# Answers to Reviewer Questions

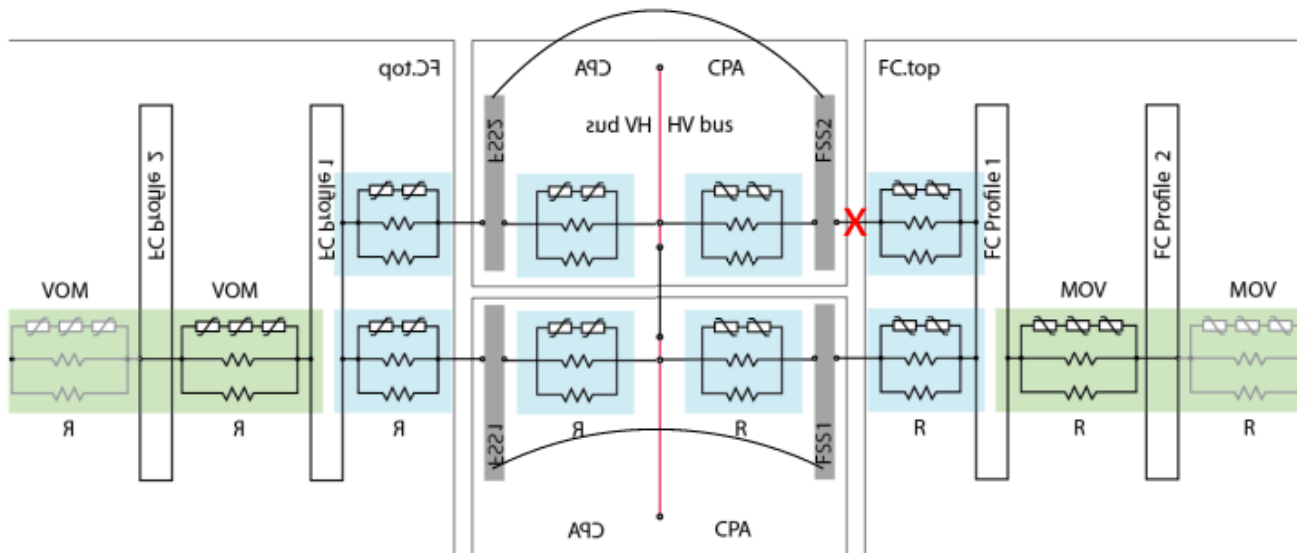
### 3. HV feedthrough: the lessons learnt from pDUNE operation have been incorporated in the proposed design for DUNE. This includes the room-T design. How long it will take to move from the conceptual to the final design and what are the tests foreseen before releasing production? Is there a specific document listing all the requirements for this item with all the design changes that have been presented?

- Only the availability of a longer PE rods need to be verified for the RT design. As soon as the vendor is identified, the time required to realize a Prototype is estimated in ~ three months: the manufacturer is able to construct a FT with the required length.

- Test can be performed at CERN B182 in Pure LAr as for the previous FT. The length is not affecting the possibility to perform the test.
- We have not formulated an official requirement document for the HVFT. However, the following requirements has been implicitly applied in the design of the ProtoDUNE HVFT:

- Hold 200 kV in Ultrapure LAr without any discharges;
  - The minimum length of the FT must be compatible with the DUNE cryostat insulation thickness and ullage depth: > 2.5m from tip to bottom of main flange;

- The bottom edge of the outer ground shield must be immersed in LAr by at least 10 cm;
  - Spring loaded tip with minimum travel of 2cm to compensate any residual thermal shrinkage and alignment error;

- Max flange size: CF250;
  - Corona discharge monitor integrated on the FT.
  - **New:** Cable termination point must be at room temperature to avoid water condensation in case of cable removal;

## 5. continued

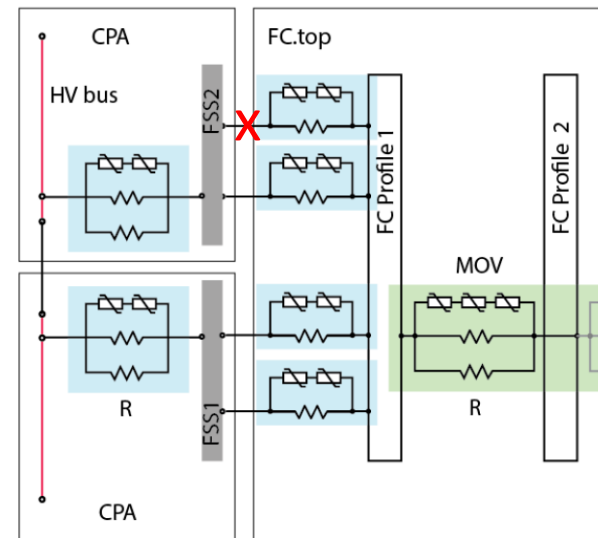
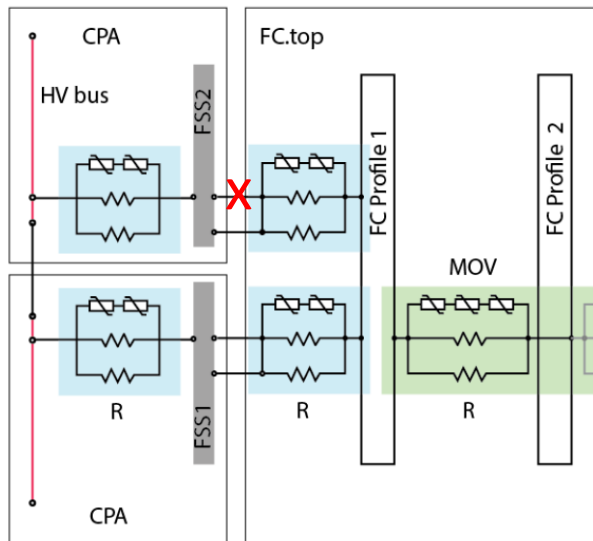
## 5. Can you comment on the QC of the connection between FC and CPA, and explain the consequences of losing that connection versus adding redundancy.

- After the top FC is mechanically tied to the two CPA panels, the long jumper wire from the FSS-FC board under the first profile of the top FC is connected to the screw terminal on the FSS. Resistance between profile 1 and the FSS terminal is verified, and so is the resistance between FSS terminal and the HV bus terminal.
- If this long jumper wire is broken (X), the bias on profile 1 will be roughly  $V_c + 6\text{kV}$ . FSS1 will be at  $V_c + 2\text{kV}$ , bias on the FSS2 will be around  $V_c + 1\text{kV}$ , determined by the resistivity of the FSS2 loop down to the bottom of the CPA where the divider boards from the bottom FC is helping to correct the shift in voltage.

- A redundant jumper connection shown in the lower left figure will be immune to a lost of connection on one of the jumpers.
- A redundant board connection such as the lower right figure will have a less severe distortion but not immune to such a lost of jumper connection.
